Malibu City Council
Special Meeting Agenda

A. Appeal of Planning Commission Resolution No. 24-39 Regarding Coastal Development Permit No. 23-004 (29738 Cuthbert Road, APN 4469-041-011, Owner Malibo LLC, Appellant Charlotte Frieze Jones, for Malibu Park Neighbors Group)

Prepared by: Aakash Shah, Contract Planner

Subject: Appeal of Planning Commission Resolution No. 24-39 Regarding Coastal Development Permit No. 23-004 (29738 Cuthbert Road, APN 4469-041-011, Owner Malibo LLC, Appellant Charlotte Frieze Jones, for Malibu Park Neighbors Group)

Figure 2a. Site Plan Showing Blueline Stream, 100 feet buffer and encroachment within 100 feet buffer

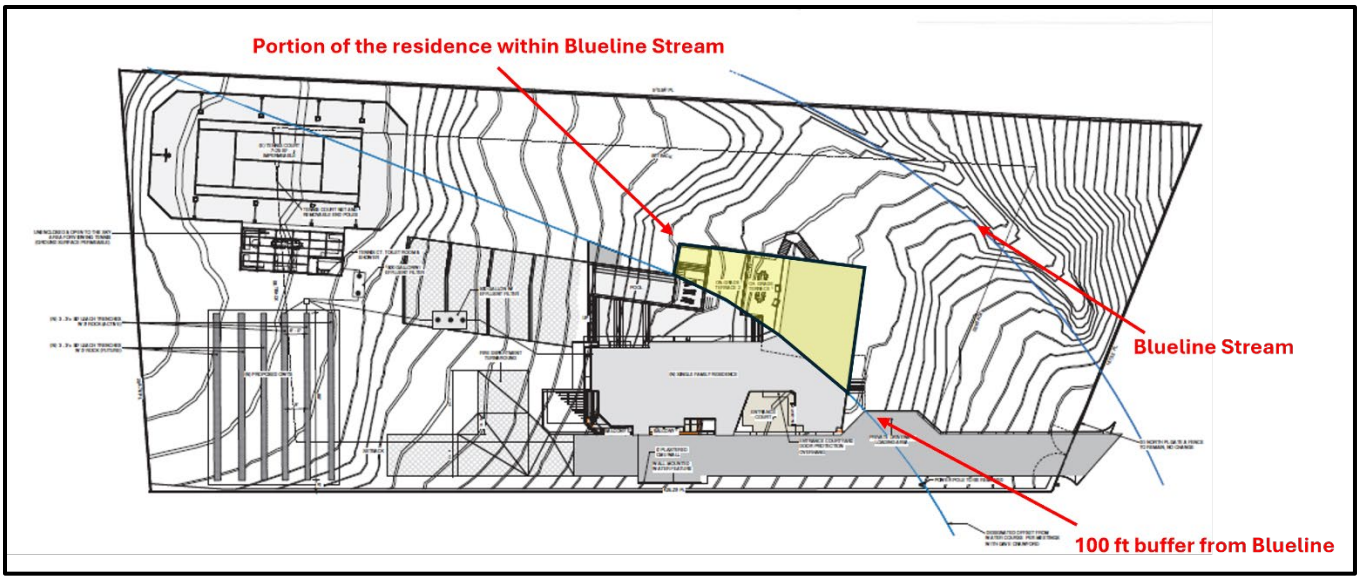
Some portions of the approved residence under PVWF No. 21-034 encroached within 100 feet of the stream (Figure 2a and 2b), as those parts were a like for like replacement. The subject application is for the addition of 4,620 square feet to the approved residence. Under this application, only the new portions of the residence are being reviewed.
